# November 16, 2017 Public Meeting

## Discuss RAI Responses with Lost Creek ISR

Discuss and clarify certain aspects of Lost Creek's responses to Staff's RAIs on the KM and Lost Creek East Amendment Application

## BE Well M-KM-5A

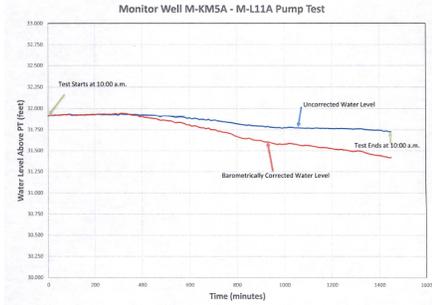
- Response is confusing
- Why did LC revise the drawdowns which used non-corrected water levels?
- Example of Well M-KM5A

- Original application
  - BE=0.83 (Vol 5 pg 150) (0.66)
  - DD = 0.50 (corrected) Table 6-3
- Response
  - BE=0.55 (pg 115)
  - DD = 0.19 (un-corrected) Table 6-3
  - (pg 138)

- The response is correct; however the correct drawdown is essentially 0.0 feet compared to 0.19 feet for the uncorrected drawdown.

# M-KM-5A Hydrographs

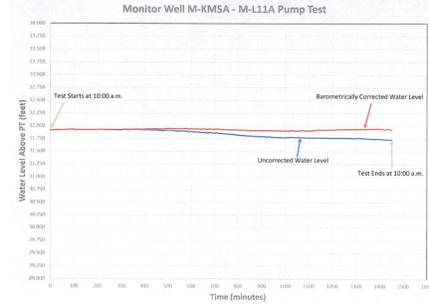
Original  
Vol 5 (Part 2) Page 336

Responses  
Page 133

Which correction is correct?

## RAI-8 Cumulative Drawdown

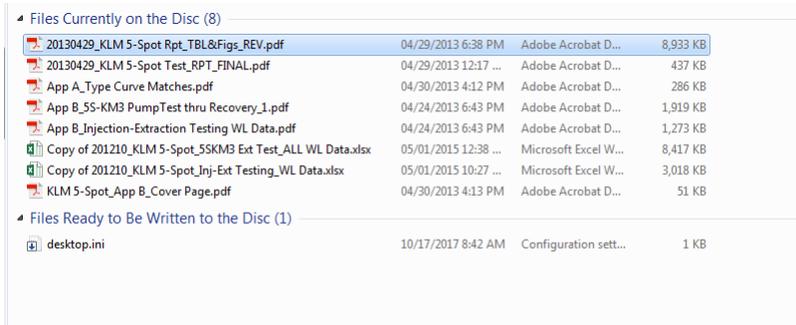
- The assumptions and staff’s analysis outside of any analysis by the licensee will not acceptable
